ALERT SERVICE BULLETIN
Bell Helicopter **TEXTRON**

NO. 206-05-105

MODEL AFFECTED: 206A/B-SERIES and TH-67

SUBJECT: TAIL ROTOR TRUNNION HOUSING SEAL 535642
INSTALLATION, ONE-TIME INSPECTION OF

Figure 1. Correct orientation of seal in housing assembly

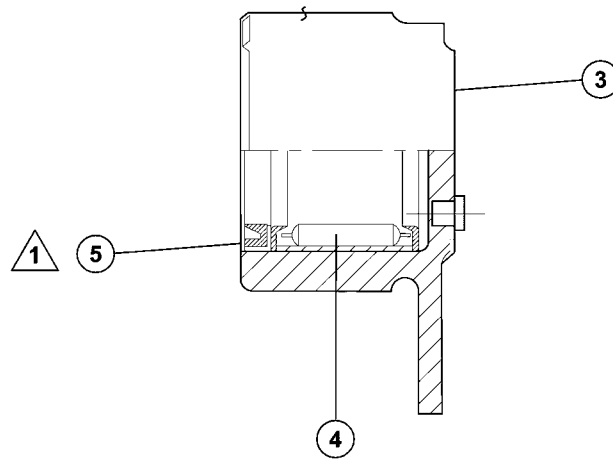
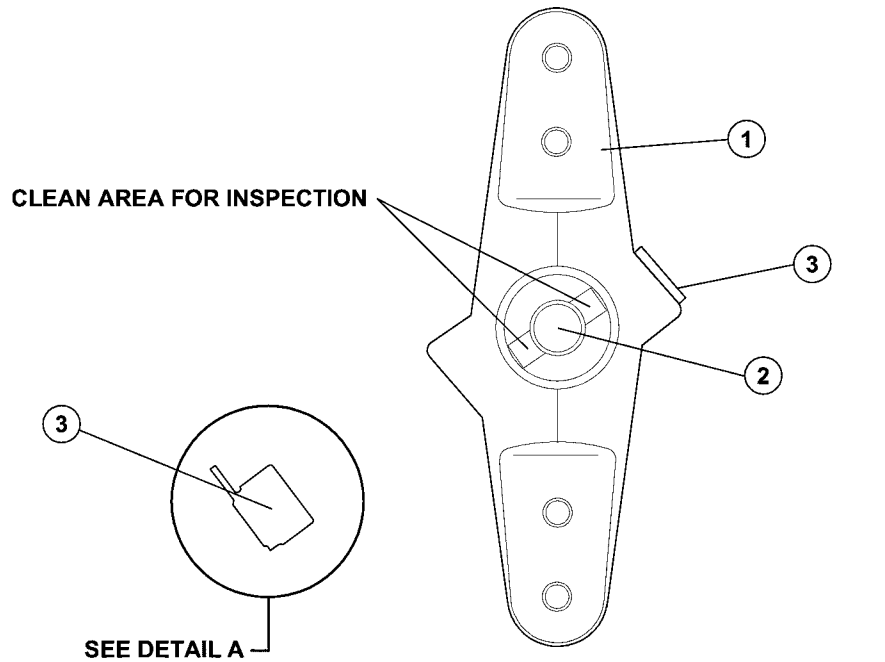
1. Inspect new housing assembly (3, Figure 1) not installed in a hub assembly (1) for correct seal (5) installation. If the housing assembly (3) is found with the seal (5) incorrectly installed, return the defective housing assembly (3) to Bell Helicopter and order a new housing assembly (3).
2. Inspect new housing assembly (3) installed in tail rotor hub assembly (1) for correct seal (5) installation. If the housing assembly (3) is found with the seal (5) incorrectly installed, perform PART III a. of this Alert Service Bulletin.
3. Inspect housing assembly (3) installed in a hub assembly (1) with time in service for correct seal (5) installation. If the housing assembly (3) is found with the seal (5) incorrectly installed, perform PART III b. of this Alert Service Bulletin.

1. Using a hand grease gun, purge grease (C-001) from bearing (4), by pumping grease into fitting, NAS 516 of housing assembly (3).
2. If normal purging of grease (C-001) from the bearing (4) can be achieved and the seal is not pushed out of the housing assembly (3) during lubrication, the seal performance in the new housing assembly (3) is acceptable and the helicopter may be returned to service. Make an entry in the Helicopter Records to show that Part II of this Alert Service Bulletin has been accomplished.
3. If restriction is felt and no grease is being purged from the bearing (4) through the seal (5) lip, perform PART III c. at your convenience but no later than the next scheduled lubrication.

1. Replace the housing assembly (3) if the seal is found to be reversed. Refer to the BHT-206B3-CR&O or to the BHT-206A/B-M&O as applicable. Make an entry in the hub assembly historical records to show that the PART III a. of this Alert Service Bulletin has been accomplished.

1. Replace the housing assembly (3) and both trunnion (2) inner races if the seal is found to be reversed. Refer to the BHT-206B3-CR&O or to the BHT-206A/B-CR&O as applicable. Make an entry in the hub assembly historical records to show that the PART III b. of this Alert Service Bulletin has been accomplished.

1. Remove the tail rotor hub and blade assembly from the helicopter. Refer to the BHT-206A/B-SERIES MM.
2. Replace affected housing assembly (3) and both trunnion (2) inner races. Refer to the BHT-206B3-CR&O or to the BHT-206A/B-CR&O as applicable.
3. Re-install the tail rotor hub and blade assembly on the helicopter. Refer to BHT-206A/B-SERIES-MM.
4. Ground-run the helicopter and perform a tail rotor balance check. Refer to BHT206A/B-SERIES-MM or the TB 206-96-163.
5. Make an entry in the Helicopter and the Component Historical Records to show that Part III c. of this Alert Service Bulletin has been accomplished.

NOTE
 Lip of seal facing toward the tail rotor gearbox output shaft.
Correct installation shown.
